# FAIRFAX COUNTY

## STAFF REPORT

APPLICATION CPA 86-C-121-10

# CONCEPTUAL PLAN AMENDMENT APPLICATION

N/S SECTION THROUGH SUNSET HILLS ROAD LOOKING WEST

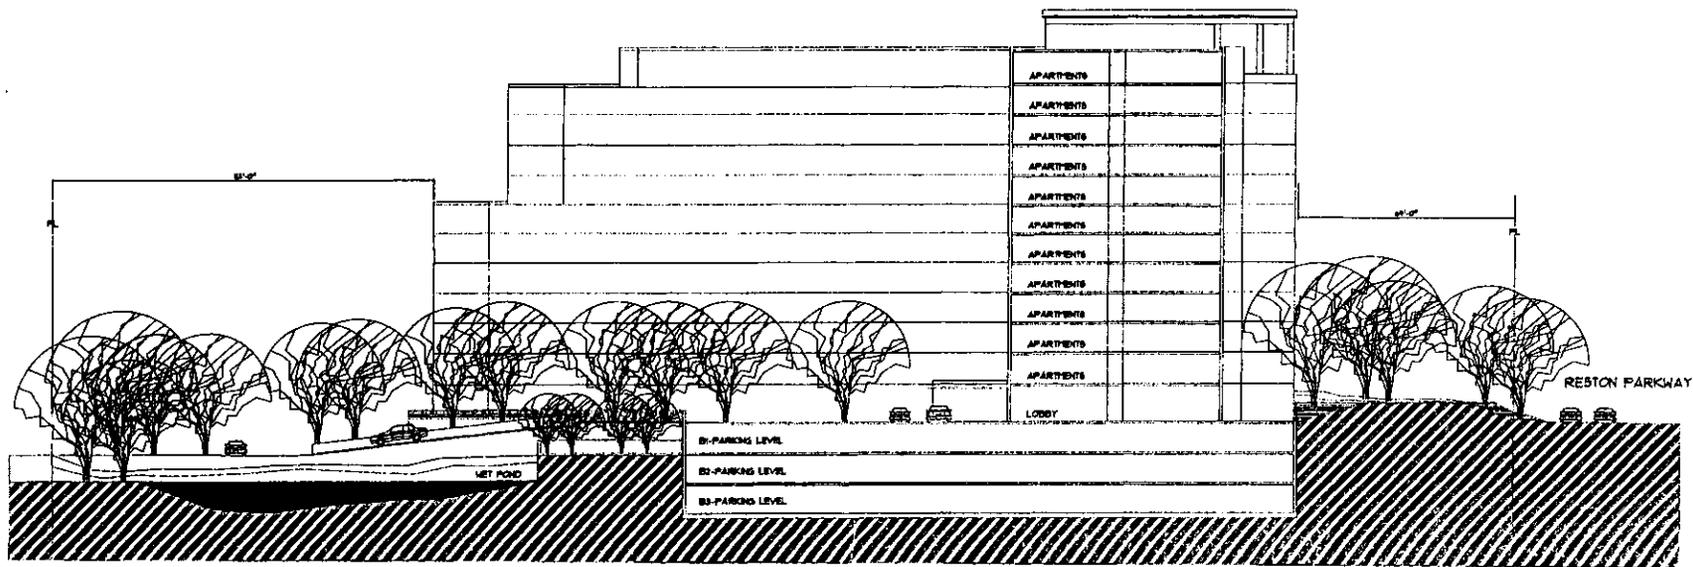
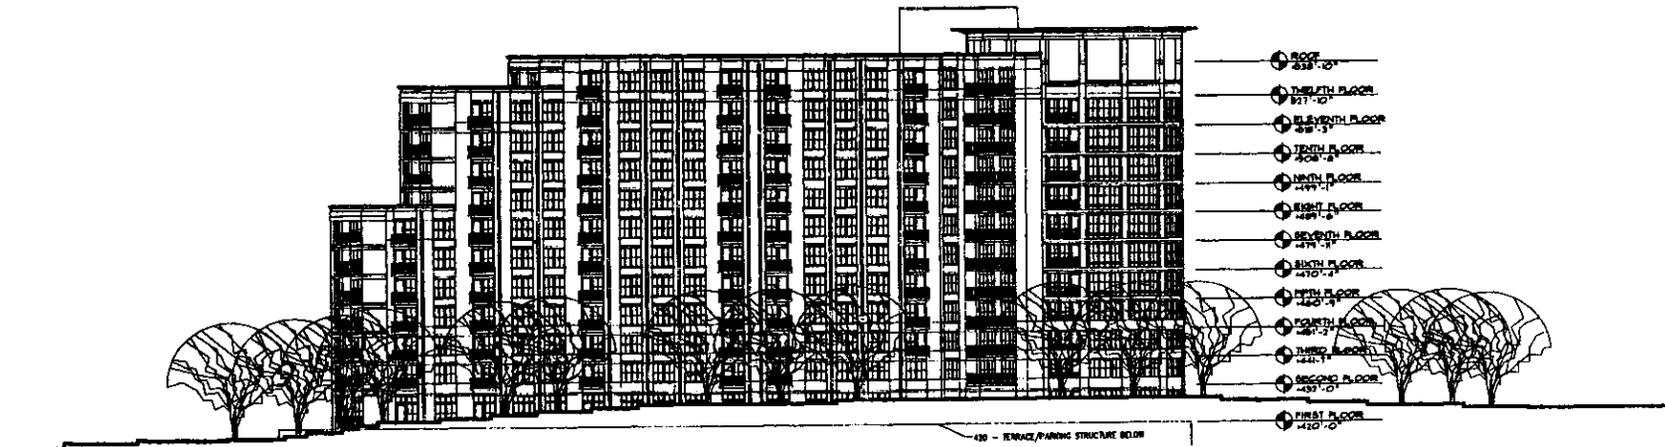
building, primarily along the Reston Parkway frontage, and elsewhere. Specific height and materials of the wall are not shown on the CPA, however based on the elevations on the CP, the retaining wall along Reston Parkway could be as high as ten (10) feet or more. Note 20 states that the walls will be constructed of concrete or masonry. These retaining walls may potentially have a significant impact on the character of the building façade and landscaped buffer. Staff would prefer that the applicant give additional detail about the wall height and adjacent landscape treatments, as well as committing to more specific building materials for the walls.
